■ INTAKE AND EXHAUST SYSTEM

■ FUEL SYSTEM

2. Intake Pipe and Exhaust Manifold Heat Insulator

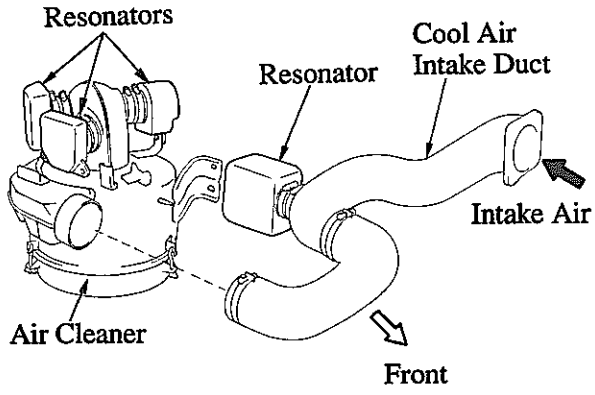
The following modifications have been made to install the engine on the new Coaster:

- The intake pipe is devided into two sections.
- A heat insulating sheet has been added to protect the air cleaner hose from excessive heat.

1. Air Cleaner

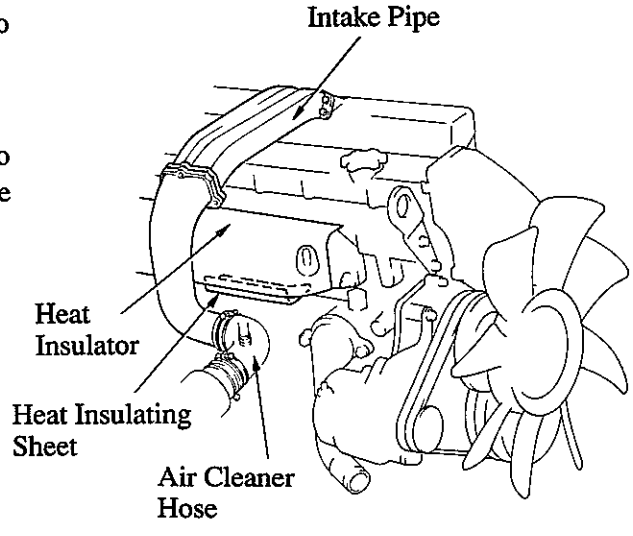
Similar to the 3B and 14B engines, three resonators have been provided in the pipe on the engine side and one in the pipe on the cool air intake duct to reduce intake noise and the noise level in the passenger compartment.

1. Injection Pump

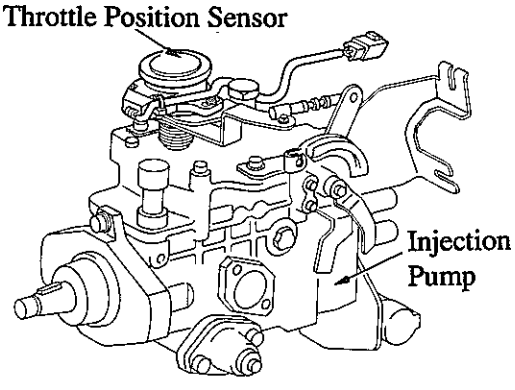
A throttle position sensor for the ECT (Electronically Controlled Transmission) has been added to the injection pump of the A441E automatic transmission models.
For details of this throttle position sensor, refer to page 71 of the Automatic Transmission section.
